**STAFF REPORT:** 01-22-2019 MEETING

**APPLICATION NUMBER:** 20-6607

**ADDRESS:** 3470 CAMBRIDGE

**SCOPE:** WORK DONE WITHOUT PERMIT

Proposed railing design for rear porches and entry

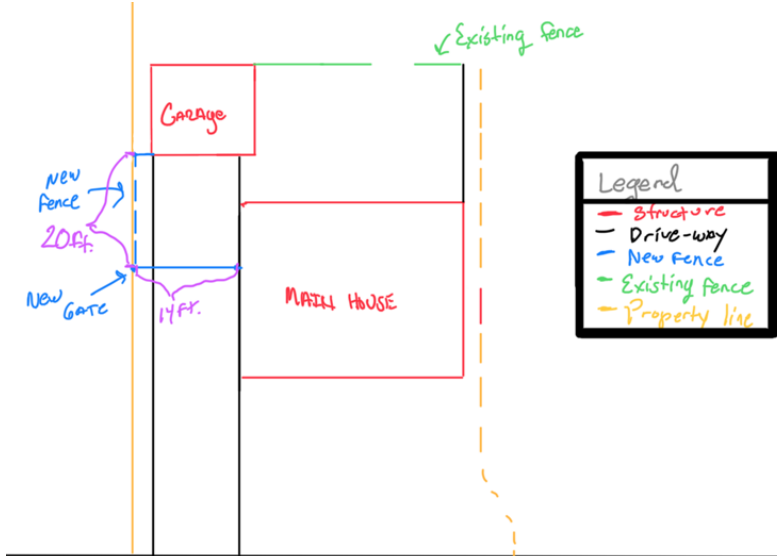
- Vinyl windows are not compatible with the historic materials on the house and not appropriate within a local historic district.
- A standard black aluminum railing for the rear patio/entry/balcony suggested by the applicant is a contemporary design and appropriate for a property line fence, but not for the house itself.
- The white steel entry doors (on the rear of the house) do not comply with Color System D.
- A catalog cut confirming the fence design was not submitted.

Proposed Gate Location

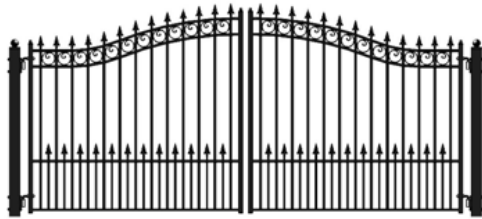
- Staff communicated with the applicant that a full fence proposal must be submitted for approval before any other fencing, beyond the small enclosure on the side of the garage which is included in this application, is installed.

- The window casing where the vent was removed shall be repaired to match the casing on the right side of the window.
- A catalog cut for the fence that will connect the gate to the garage shall be submitted for staff review.

## Replace Garage Door

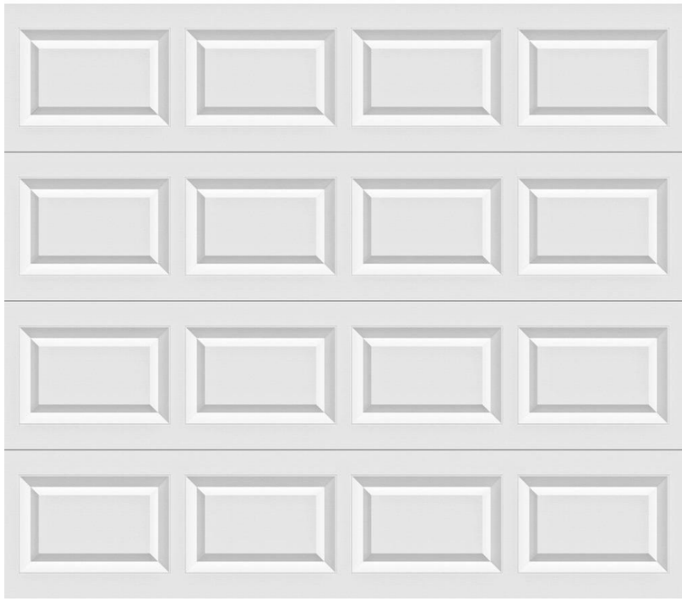
- Garage door (hasn't been completed yet) – single overhead steel door (reddish brown) to be replaced with a four panel overhead aluminum door (black). *This door is completely ruined and needs replacement to be functional and not look terrible (before pics). We were going to get a black or clay colored door to match the roof or windows, keeping the same style as the one that is there currently.*

Original Windows – additional photos supplied by applicant

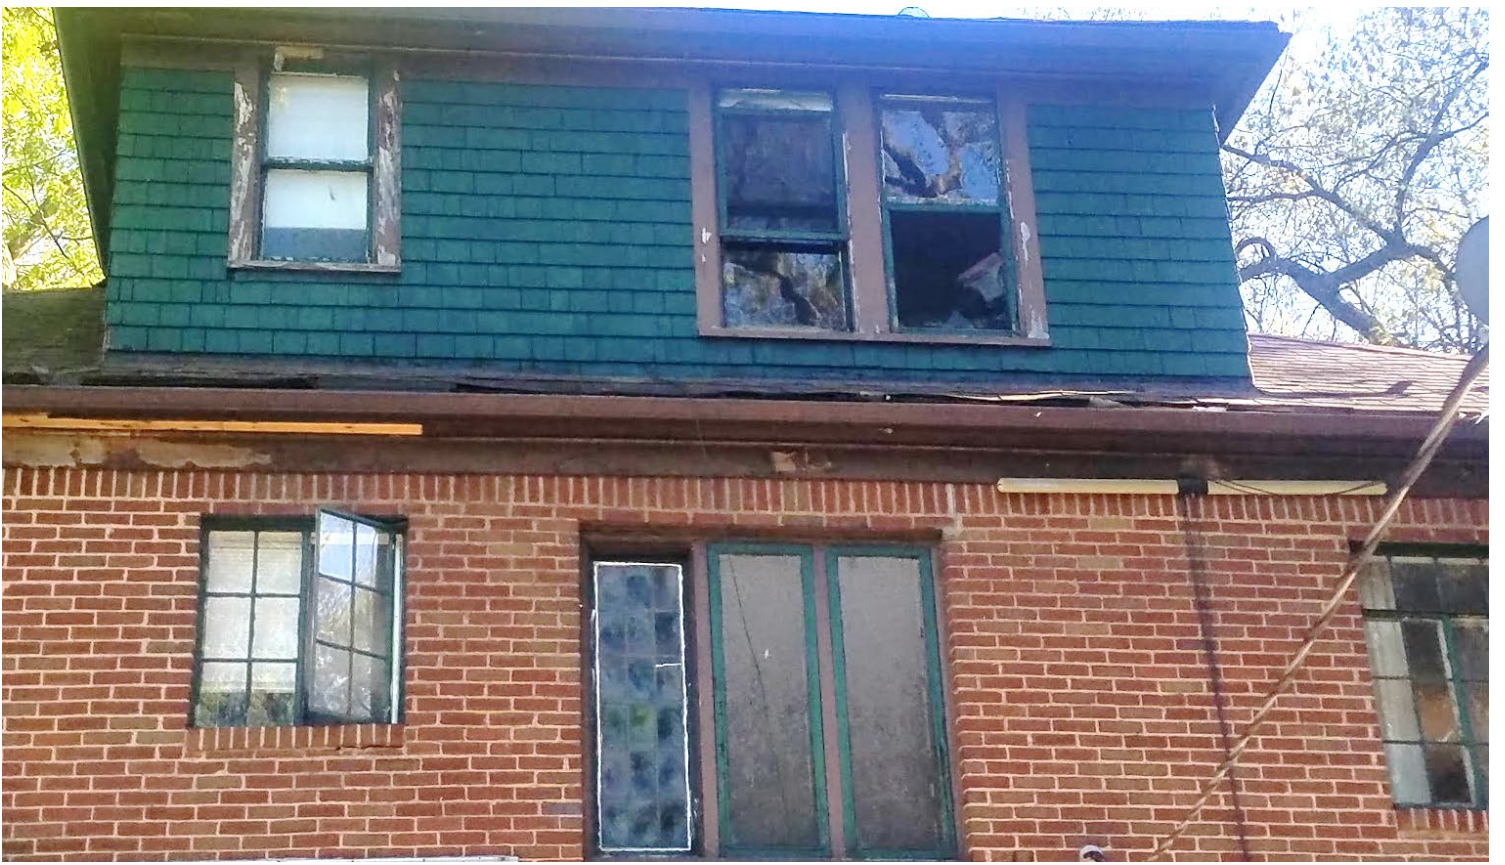
- The windows were replaced without detailed analysis as to the existing conditions and repair options/pricing from window companies with experience in steel window repair. Staff requested additional photographs of the windows before they were replaced showing the deterioration levels of the windows. They follow the photo narrative of the multiple projects.
